RE: 7 World Trade Center
Mayor's Office of Emergency
Management -1st, 7th, & 23rd Floors
Chang Order #38

Re: 7th Floor Louvers
7 World Trade Center
Change Order #038
Amb. Job #S57-5175

SKP-4

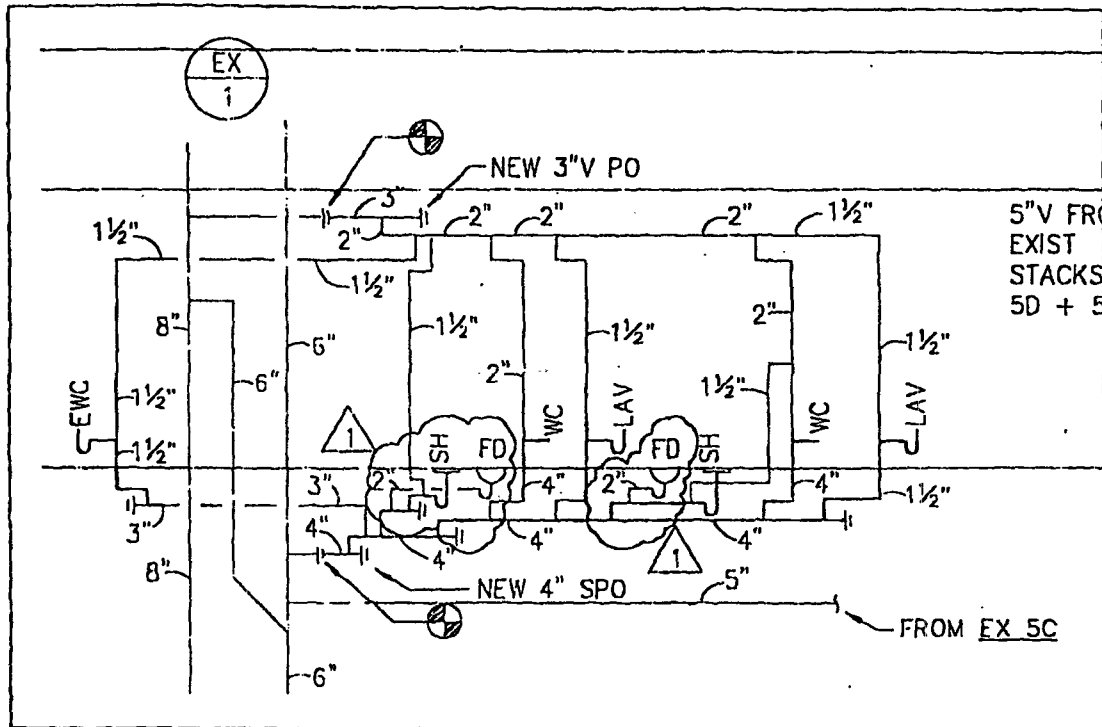
As per SKP-3 and SKP-4 for additional drains in H.C. toilets 23-32, 23-3 and for installing a new drain in sprinkler closet 23-22 the costs are:

1 ADDED FLOOR DRAINS

2 ADDED FLOOR DRAINS
